ADMINISTRATIVE STAFF REPORT

Project Name: Membrere Critical Area Buffer Reduction

Type of Application: Critical Area Buffer Reduction (CABR, Type II)

Permit Number: 21-02549

6. Site Design

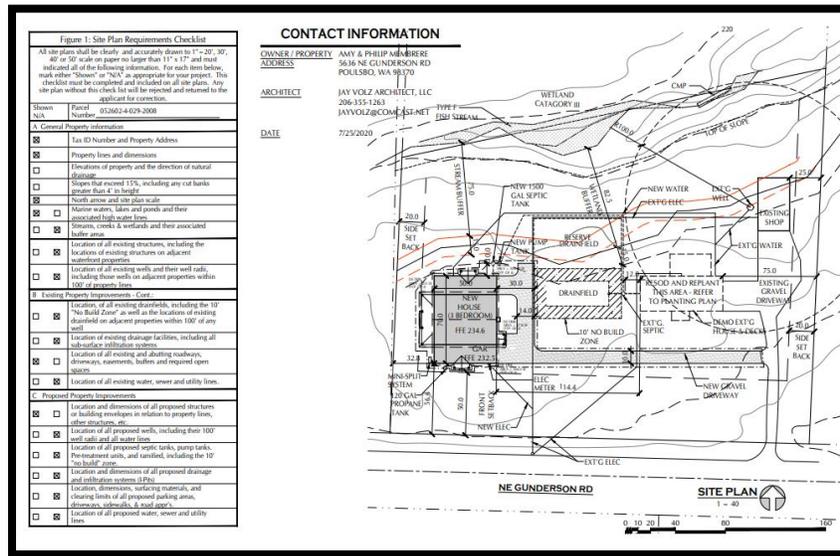
The image below shows the proposed footprint of the home and associated drainfield as well as the existing driveway. The site plan also shows the location of the onsite wetland and stream.
